Safety Alert 015

Title: BEKO gas cooker product range modification

Date issued: 5 August 2014

BEKO Plc Installation/modification Instructions

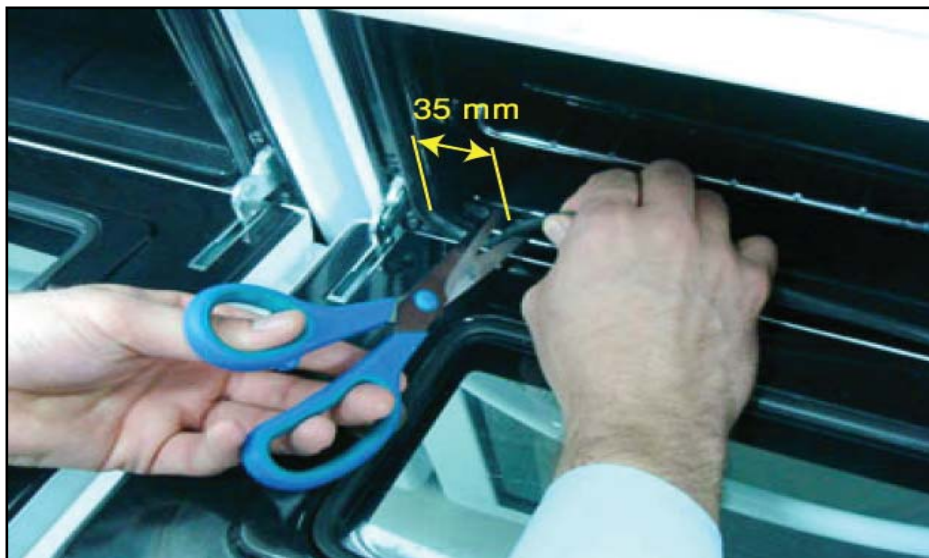
To ensure that there is an adequate supply of combustion air to the grill burner in the event that the grill door is inadvertently closed during the grilling process, a modification that involves removing the bottom section of the cavity door seal has been developed.

It is important that during installation of this product that you carry out the following modification to the Grill door seal **prior** to installation.

Open the Grill Door

Pull the bottom of the seal away from the cooker without removing the hooks from the hole and cut the seal 35mm in from the hook on both the bottom left hand and right hand corners of the seal as shown in the picture below and remove the bottom piece of the seal.

Close the Grill Door
